# STATE OF OHIO DEPARTMENT OF TRANSPORTATION

## GRE-68-12.65

XENIA TOWNSHIP

GREENE COUNTY

# PHASE 2 MAINTENANCE OF TRAFFIC PLAN

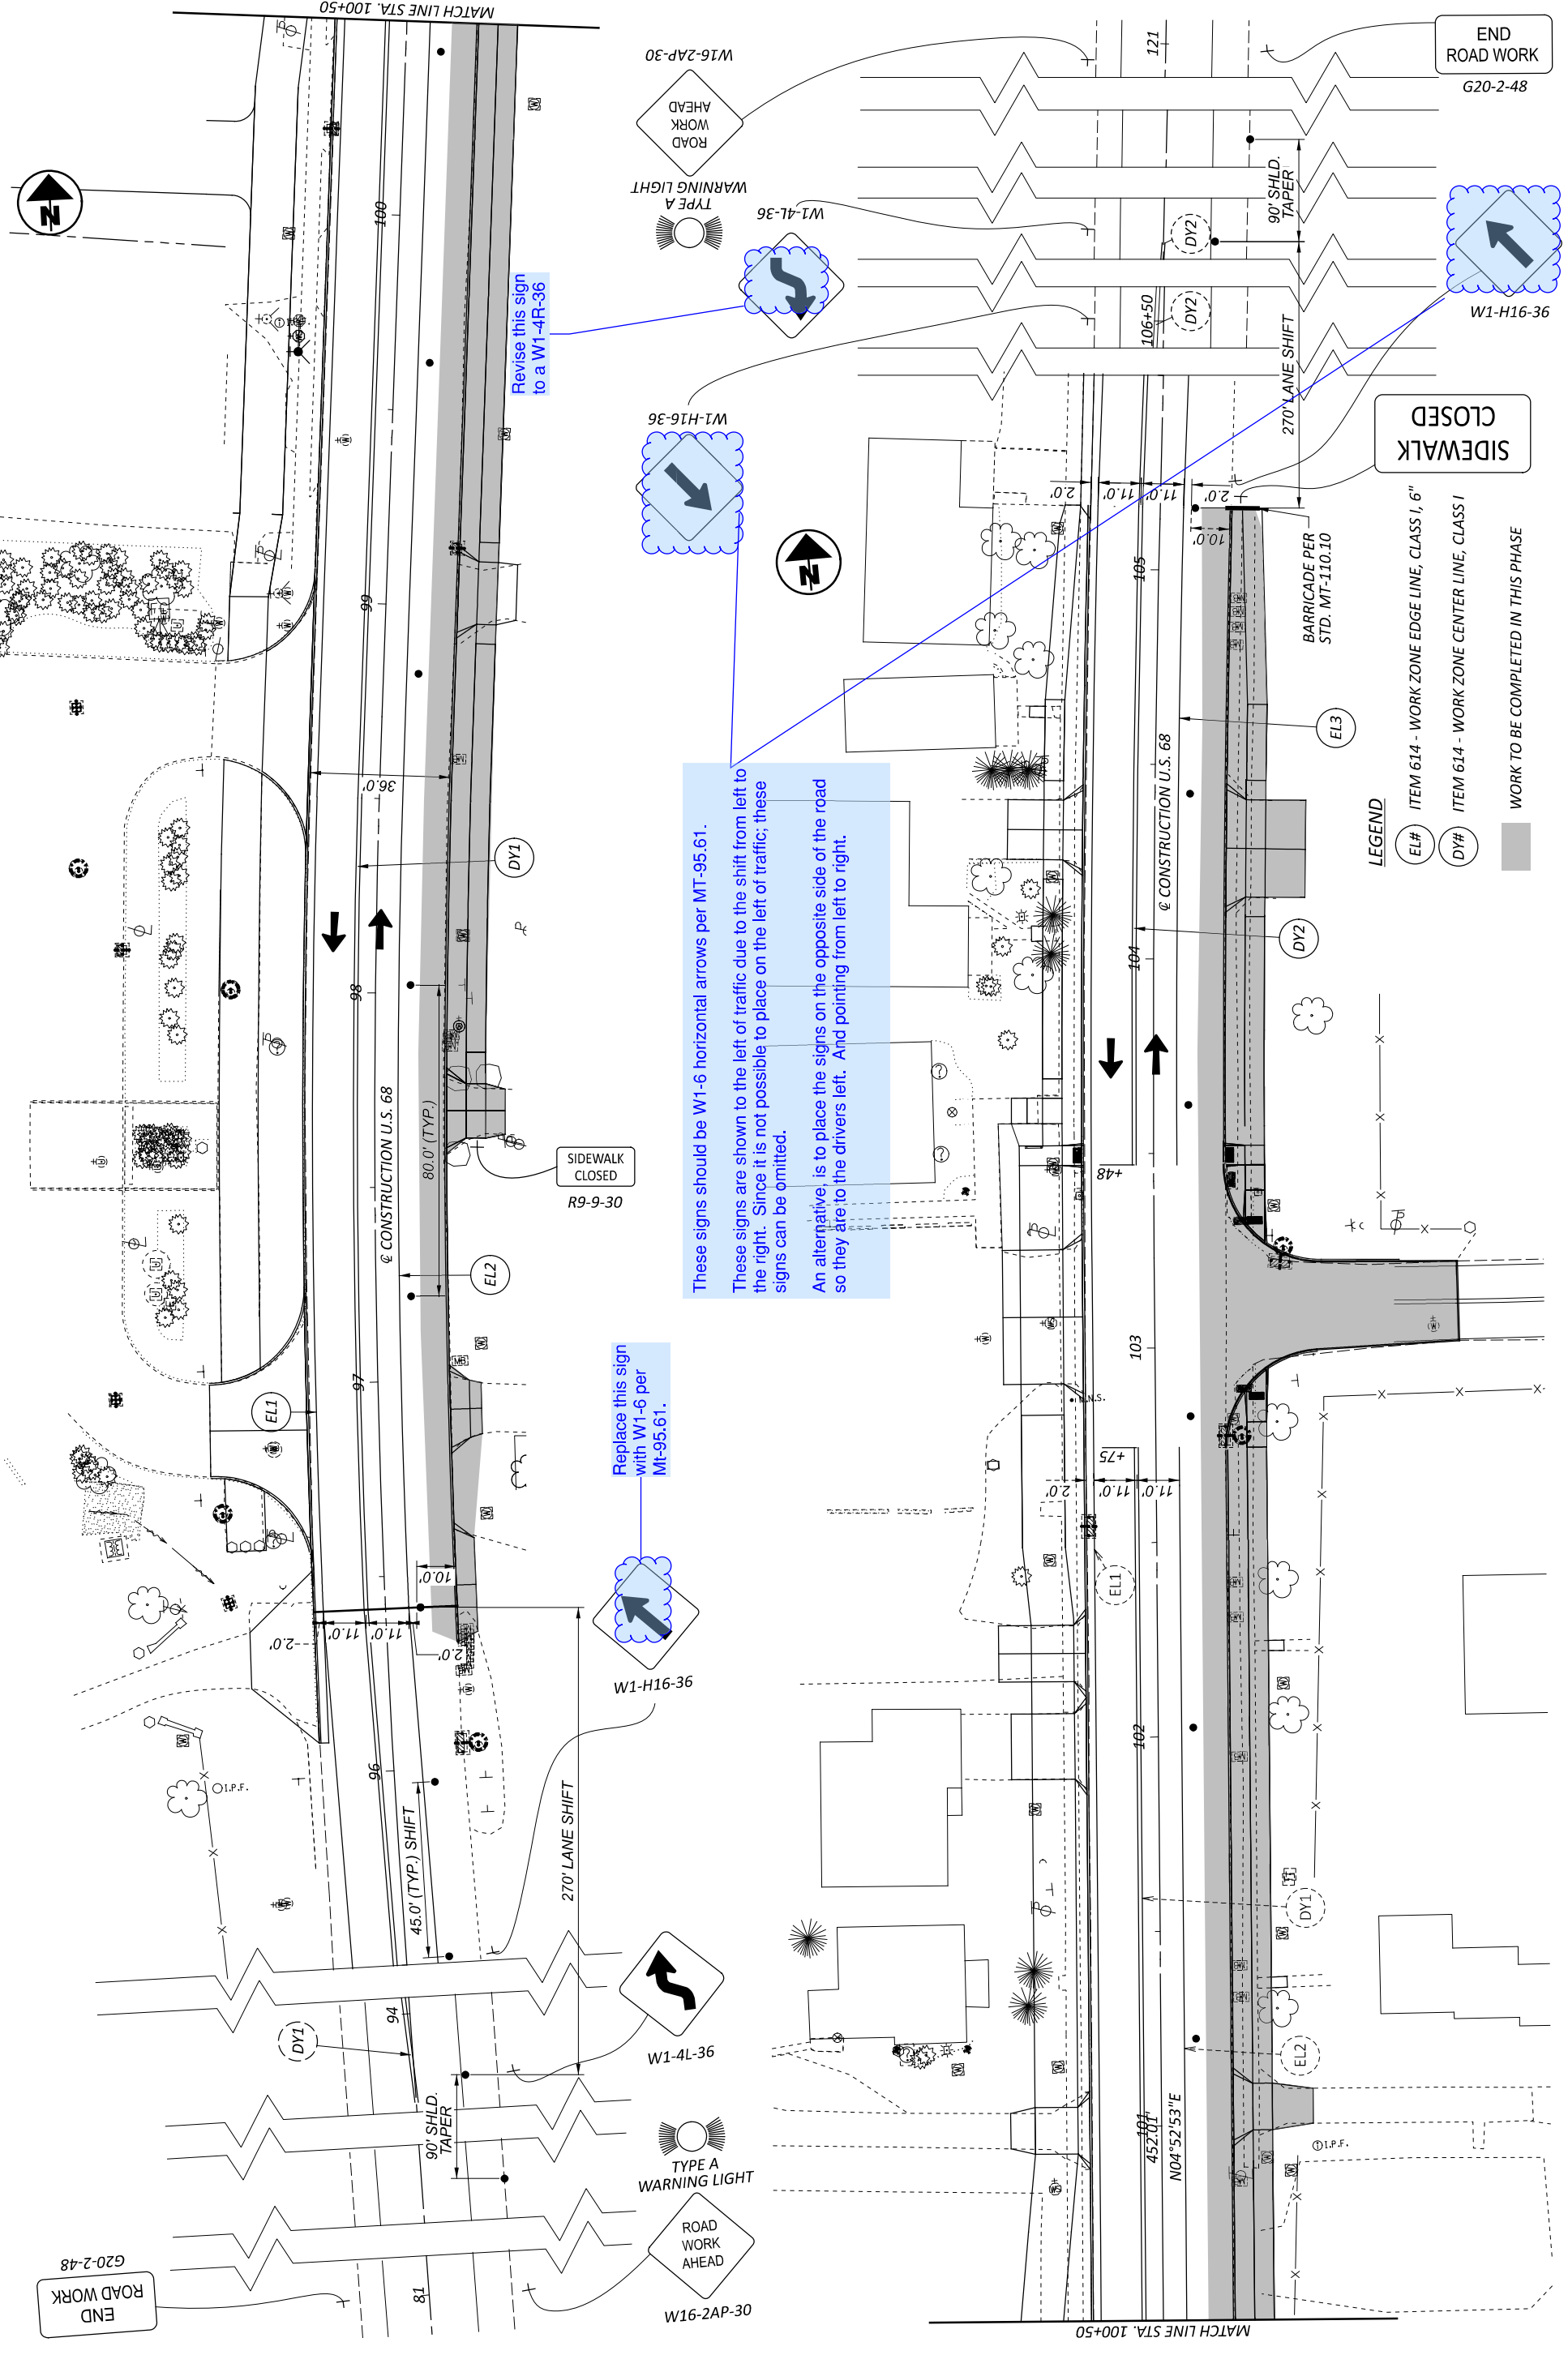
Replace this sign with W1-6 per Mt-95.61.

These signs should be W1-6 horizontal arrows per MT-95.61. These signs are shown to the left of traffic due to the shift from left to the right. Since it is not possible to place on the left of traffic; these signs can be omitted. An alternative is to place the signs on the opposite side of the road so they are to the drivers left.

These signs should be W1-6 horizontal arrows per MT-95.61.  
These signs are shown to the left of traffic due to the shift from left to the right. Since it is not possible to place on the left of traffic; these signs can be omitted.  
An alternative is to place the signs on the opposite side of the road so they are to the drivers left. And pointing from left to right.

Revise this sign to a W1-4R-36

Replace this sign with W1-6 per Mt-95.61.

PLAN AND PROFILE - U.S. 68  
 STA. 95+50.00 TO STA. 100+50.00

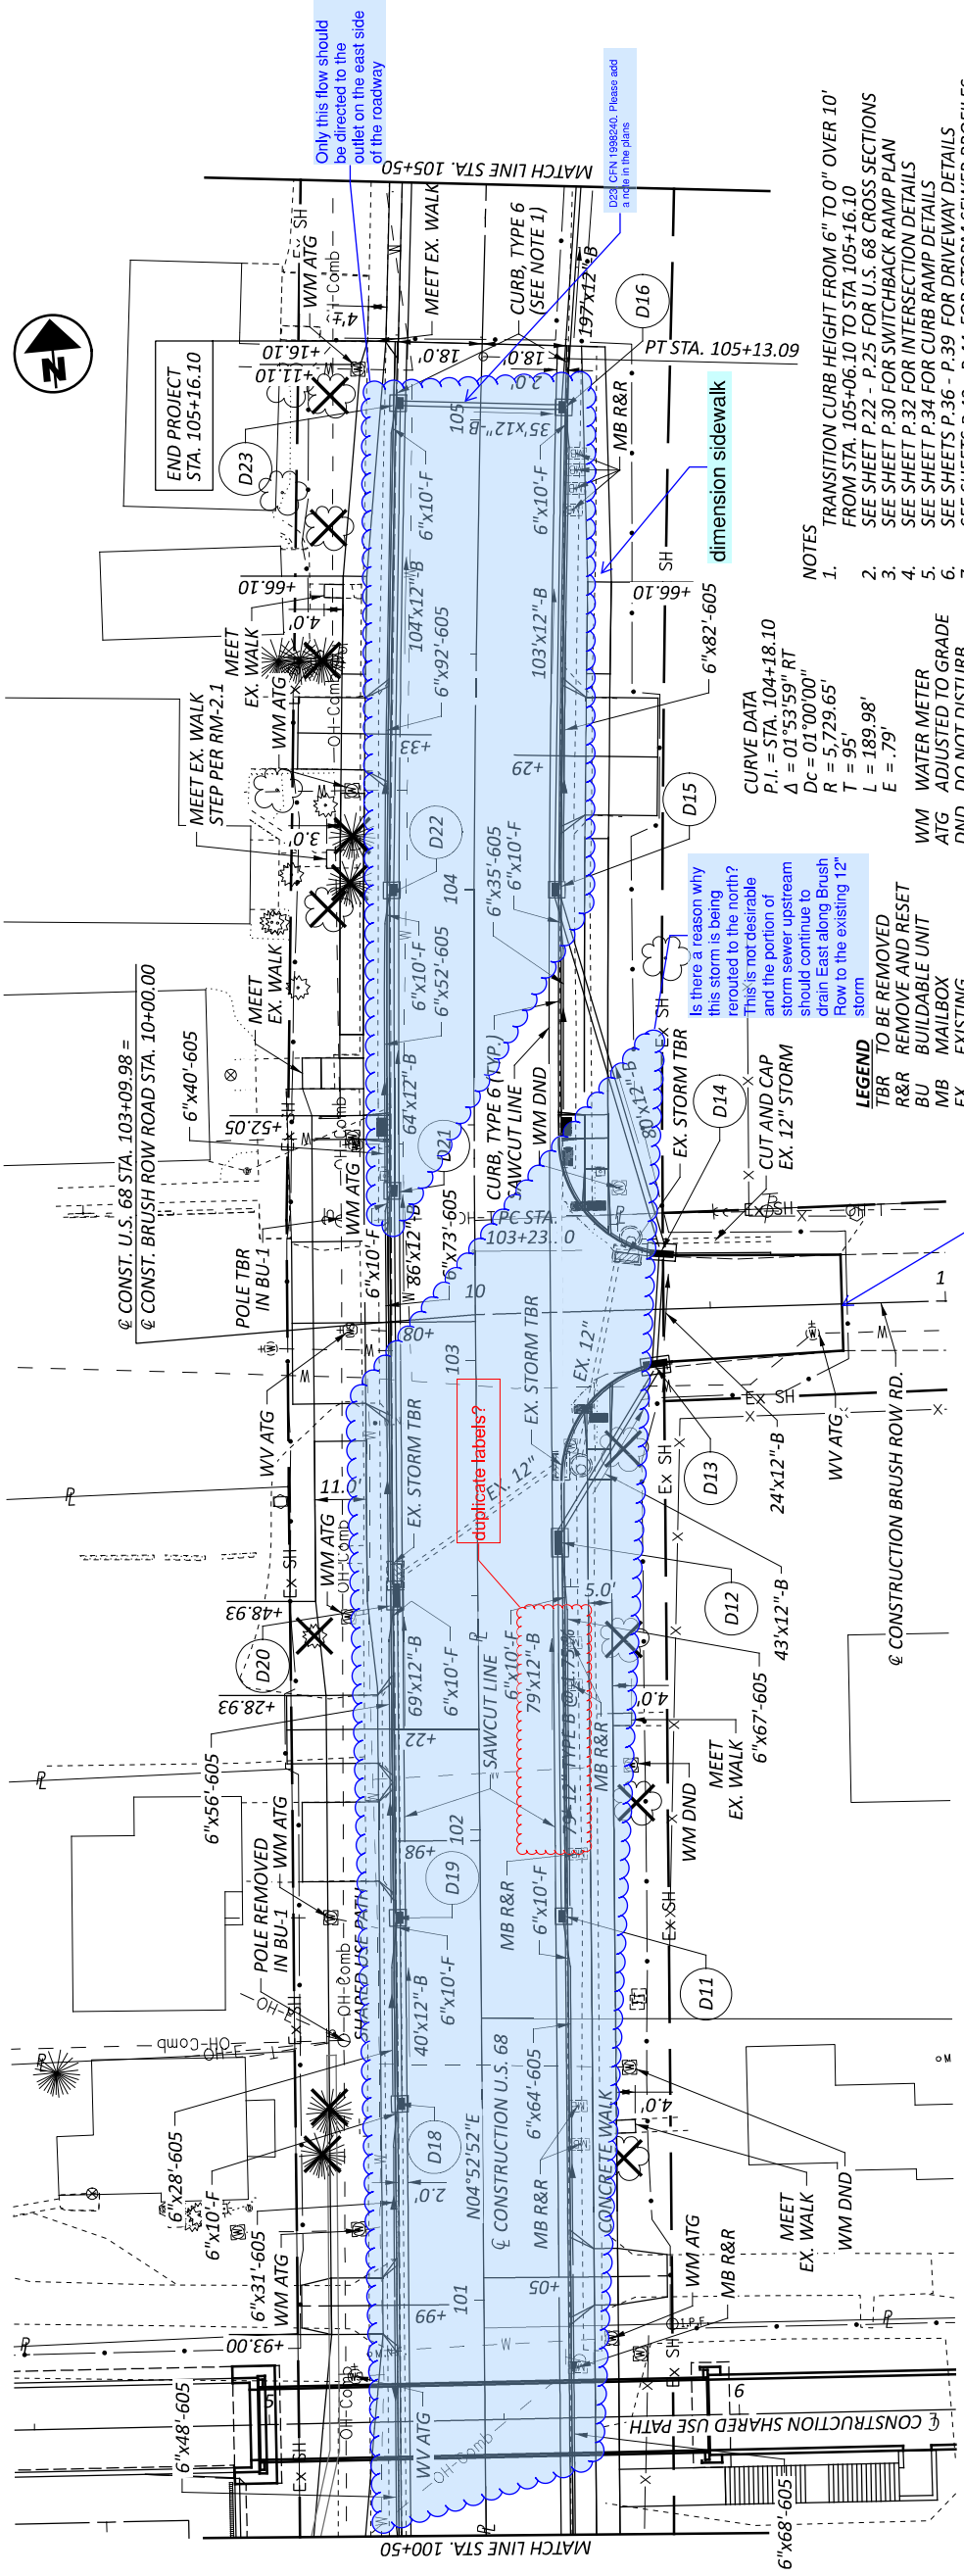
7' of 15" type B between D1 and D2.

Callout needed for 15" storm sewer

PLAN AND PROFILE - U.S. 68  
 STA. 100+50.00 TO STA. 105+50.00

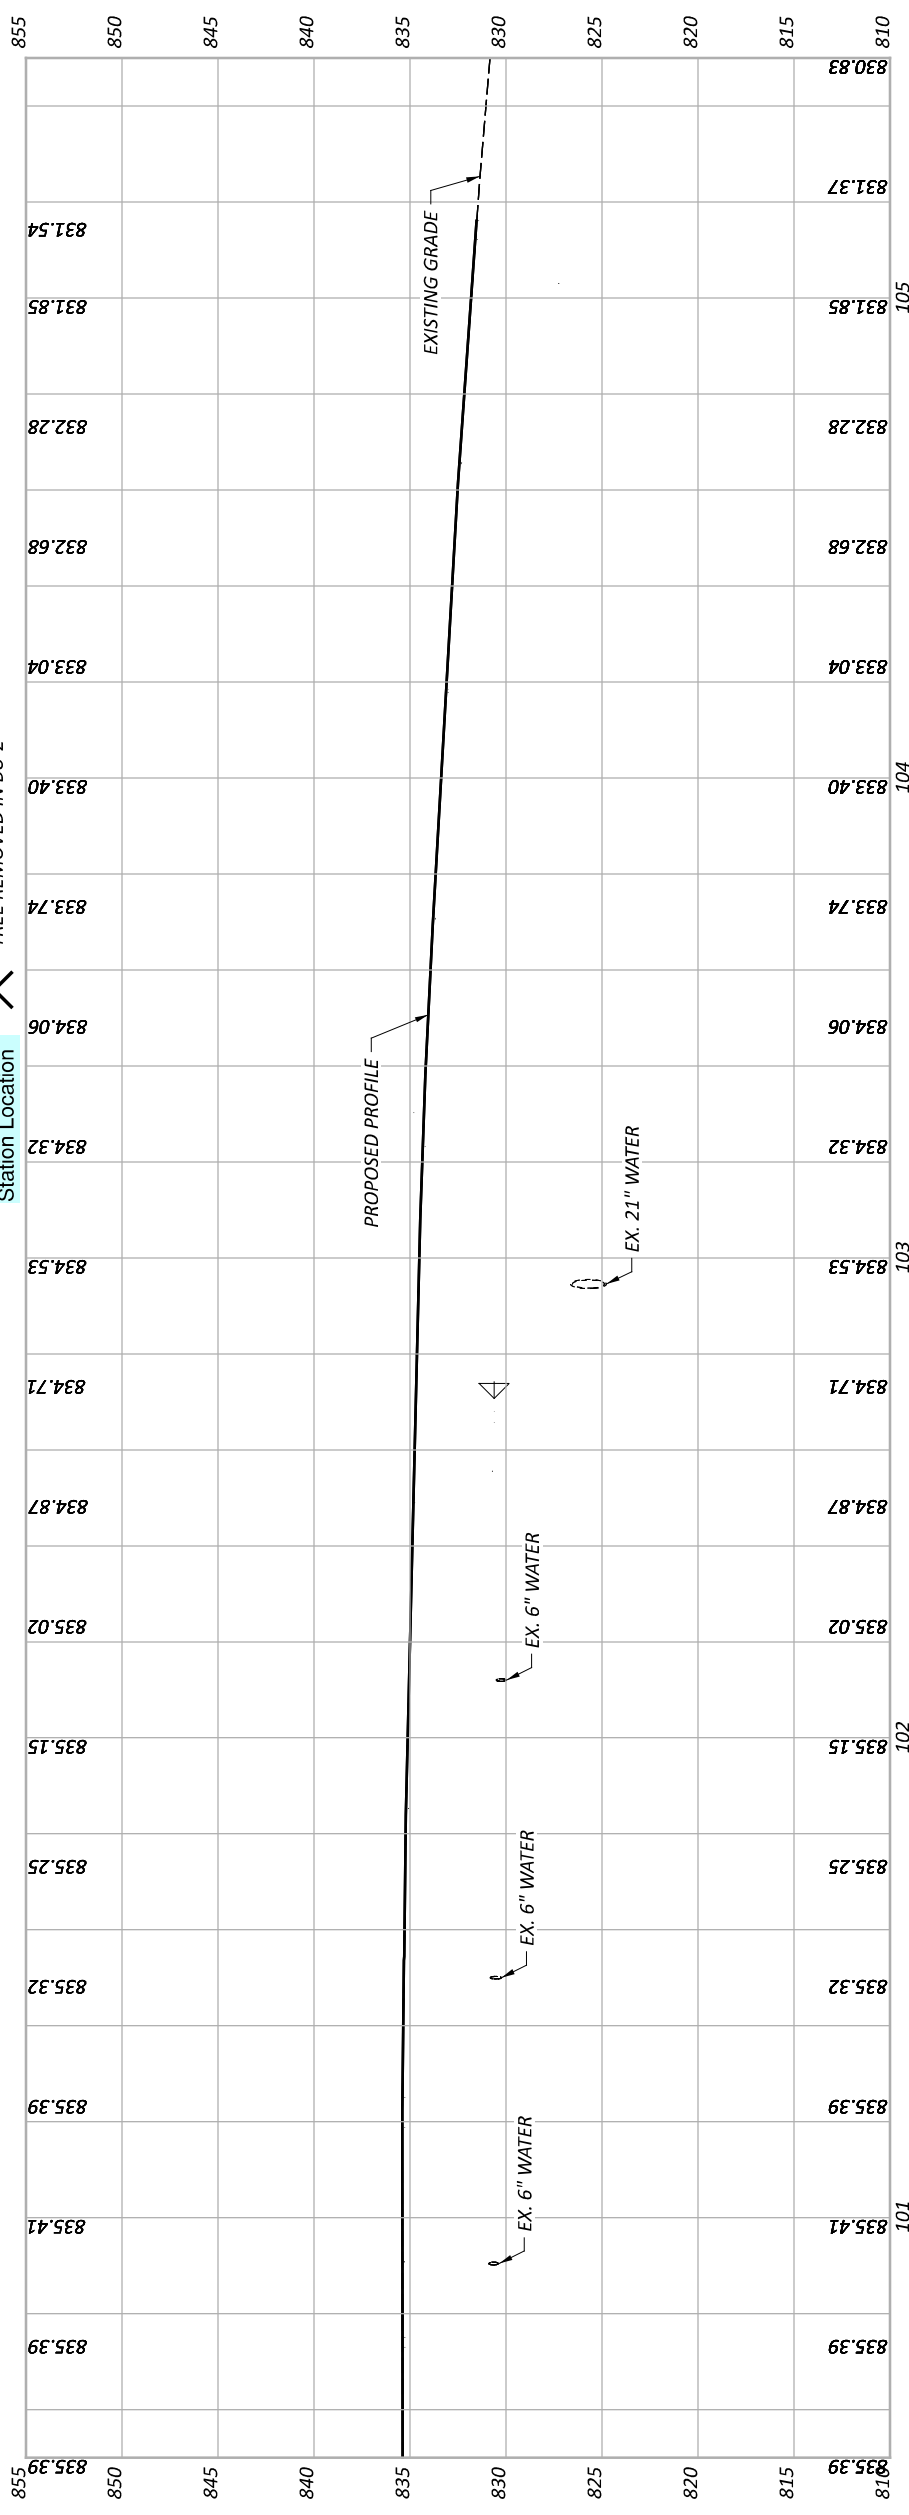
Only this flow should be directed to the outlet on the east side of the roadway

D23 CFN 1988240. Please add a note in the plans

PLAN AND PROFILE - U.S. 68  
 STA. 105+50.00 TO STA. 108+50.00

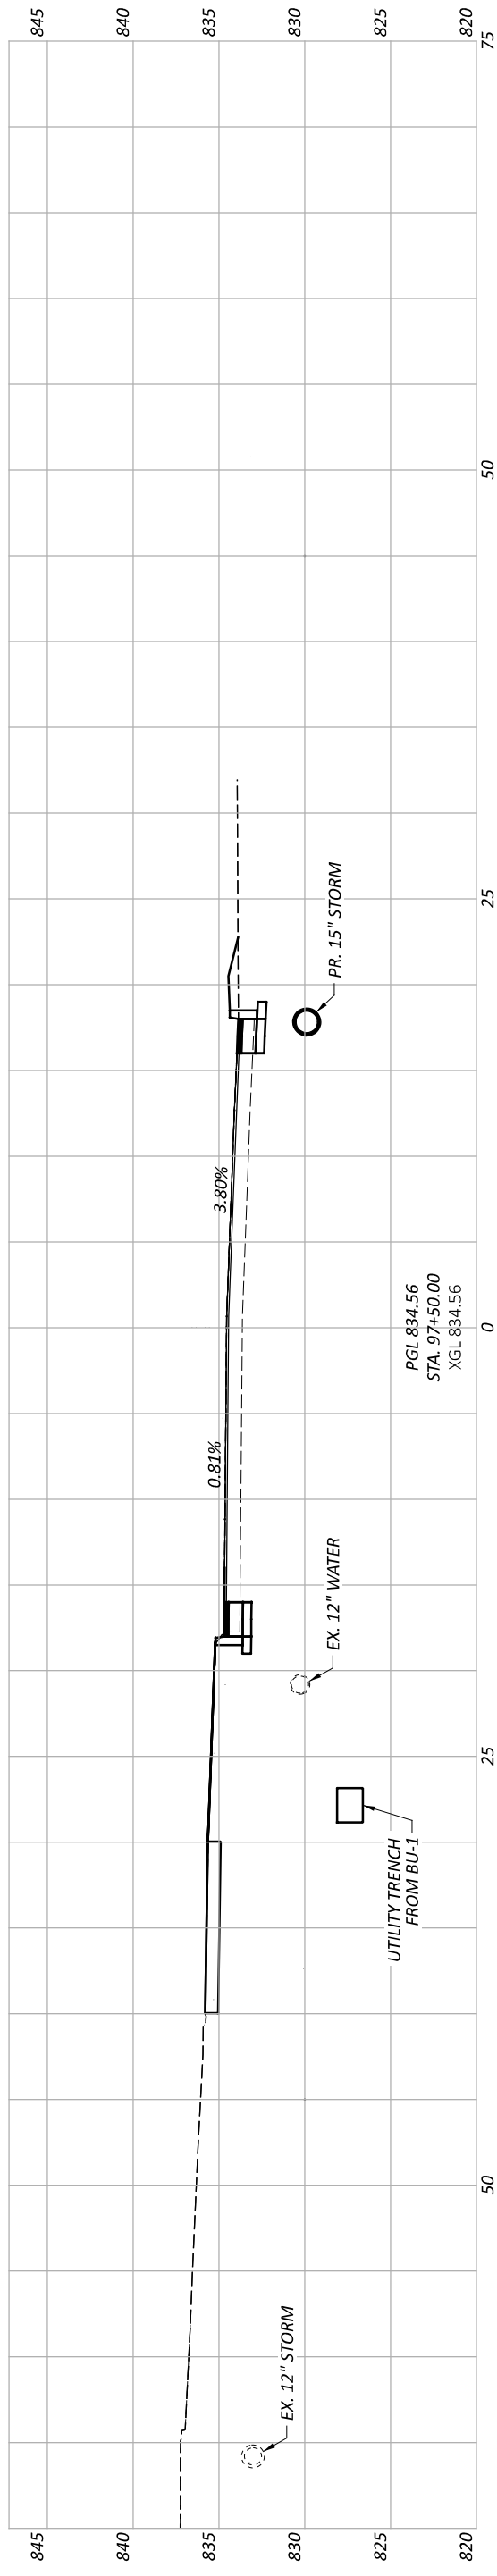
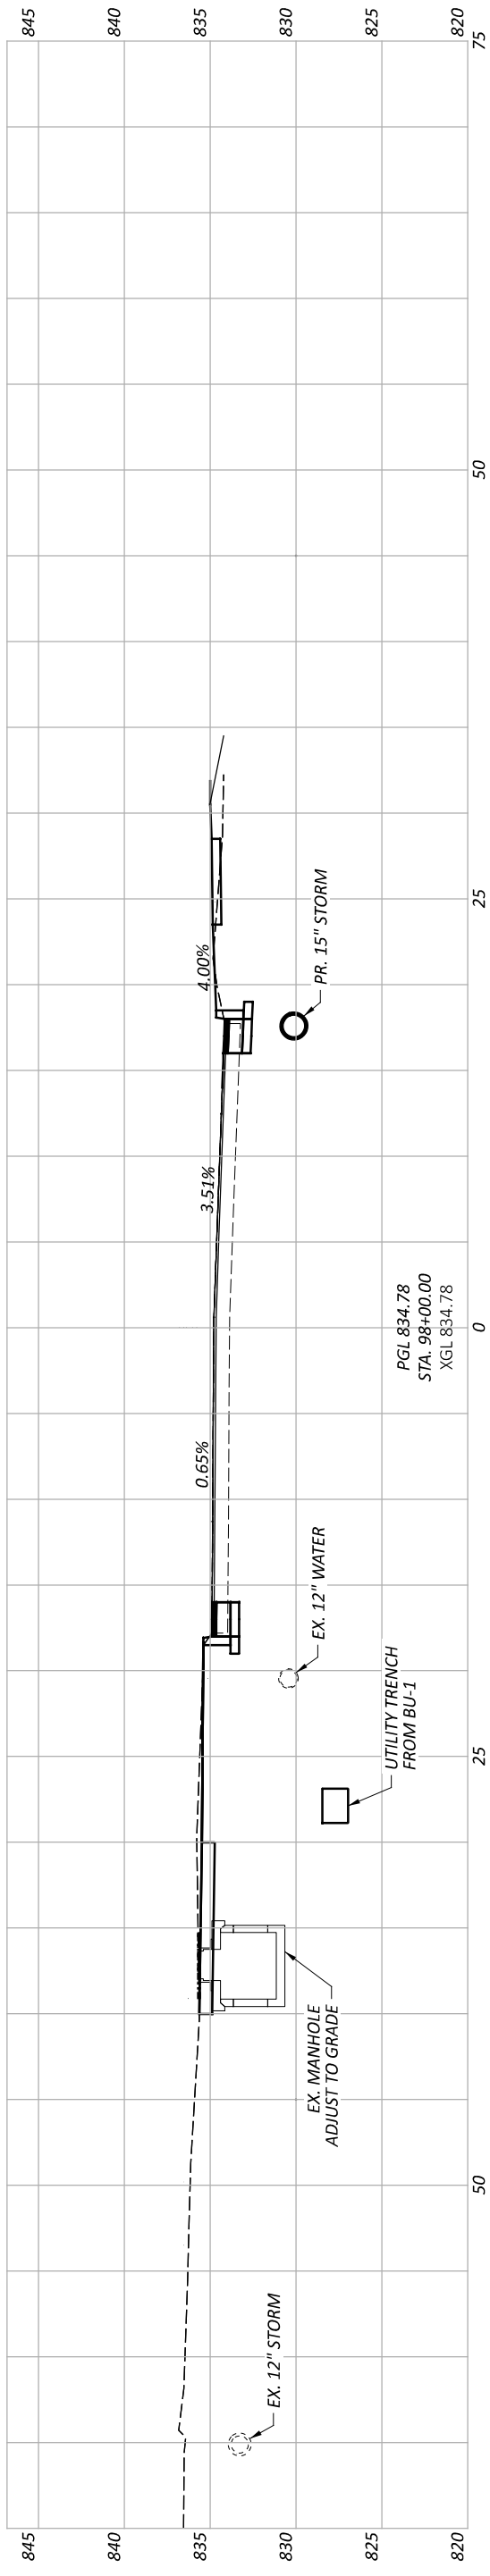
There is a ditchline along the roadway that will likely need to be used. Drainage to the NE probably won't work. There are two drive pipes that would likely need replacement.
